## PCI-SIG ENGINEERING CHANGE REQUEST

<b>TITLE:</b>	Display-Mini Card (DMC) Definition
<b>DATE:</b>	Updated April 02, 2009 (Initial request – July 21, 2008)
<b>AFFECTED DOCUMENT:</b>	PCI Express Mini CEM Revision 1.2
<b>SPONSOR:</b>	Ron Shaw, Dell Incorporated

Figure 2-3: Display-Mini Card Form Factor (Wireless Example Application Shown)

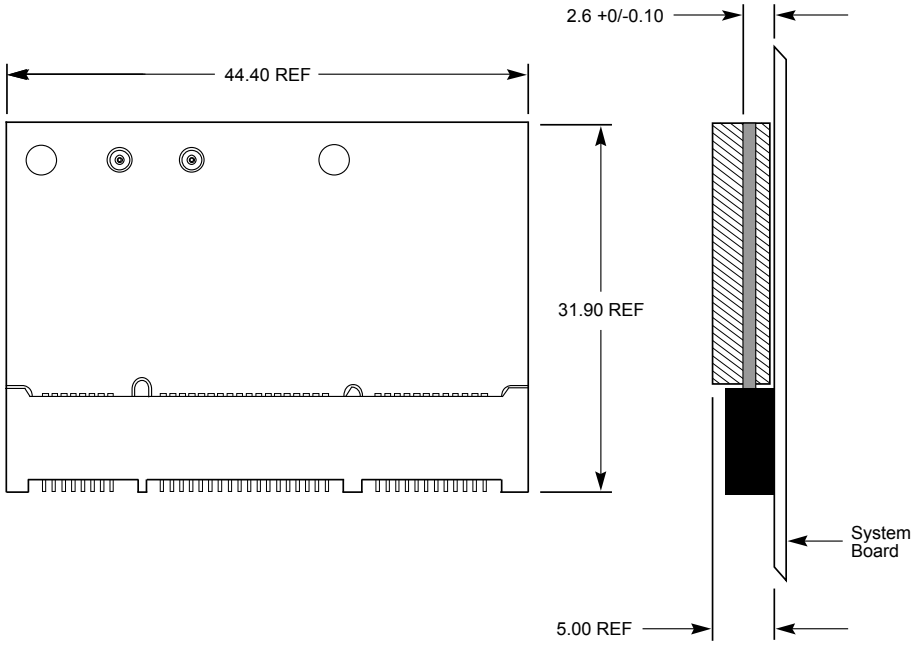
A new modified form factor, Display-Mini Card (DMC) based on the current Half-Mini Card (HMC, ver. 1.2) definition which adds additional pins and board space to allow for DisplayPort to be routed through the new connector.

1. A full DisplayPort (DP) interface will be added to the connector. This requires an additional 24 pins to provide the DP interface and DMC-specific signals.
2. The width of a DMC will increase by 14mm more than the current HMC to accommodate the additional 24 pins.
3. The power definition of the DMC will be increased to support the additional area and the projected requirement for future radio trends.
  - a. Thermal will increase to 3.3 Watts
  - b. Electrical power delivery may increase.

A new form-factor, 44.40mm x 26.80mm, will be defined. A new connector to support the additional size and pins will be defined.

**Figure 2-11: Card Component Keep Out Areas for Display-Mini Cards**

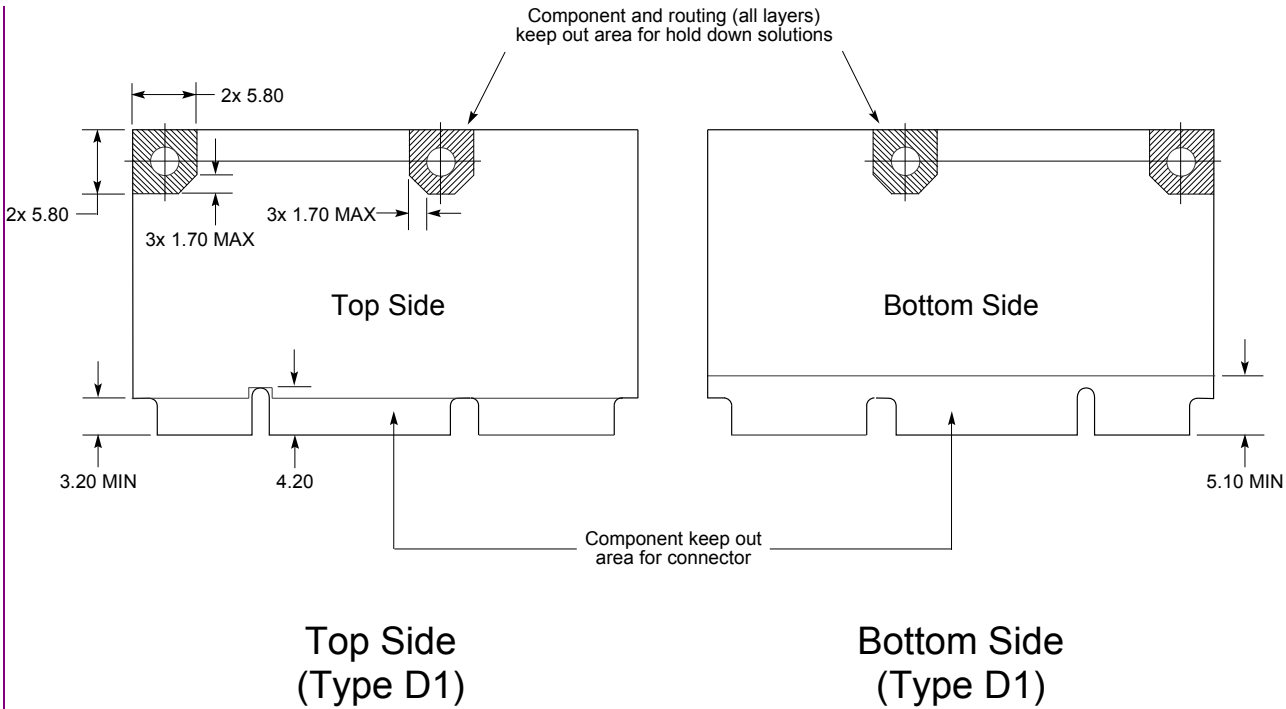
The remaining figures in this section provide details regarding the component keep out areas on Full-Mini (Types F1 and F2), Half-Mini Cards (Types H1 and H2) and Display-Mini Cards (D1).

Figure 2-13: PCI Express Display-Mini Card System Connector

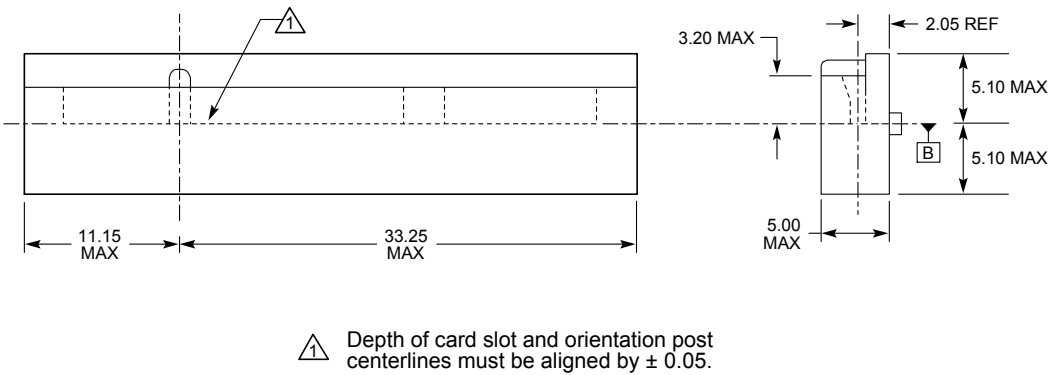
[The system connector for Display-Mini cards is a 76-pin card edge type connector. Detailed dimensions should be obtained from the connector manufacturer. Figure 2-13 shows this version of the system connector.](#)

**Figure 2-20: Recommended System Board Layout for Dual-Use Display/Half-Mini Card Socket**

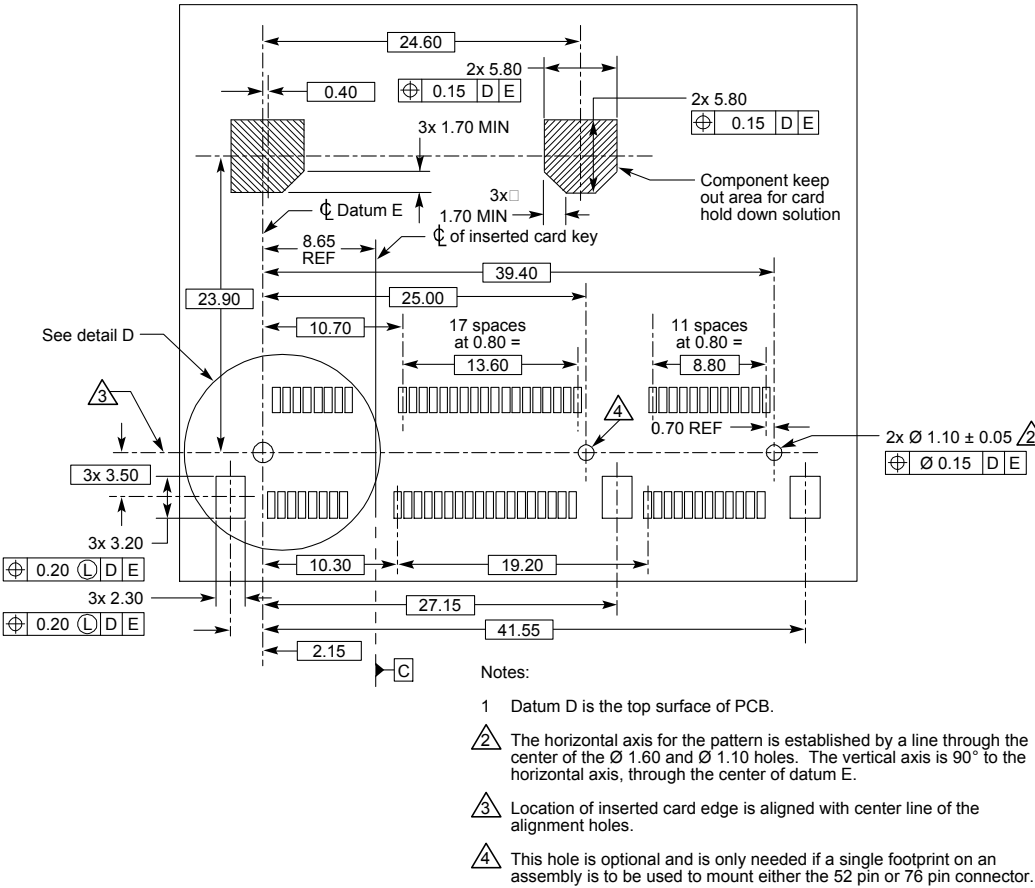
Figure 2-20 shows the recommended system board layout for a dual-use socket that can accept either a Display-Mini Card or a Half-Mini Card. While this socket uses the 76-pin system connector

specific to the Display-Mini Card application, the hold down support allows for the installation of a Half-Mini Card into the same socket. All Display and Half-Mini Cards are compatible with this socket.
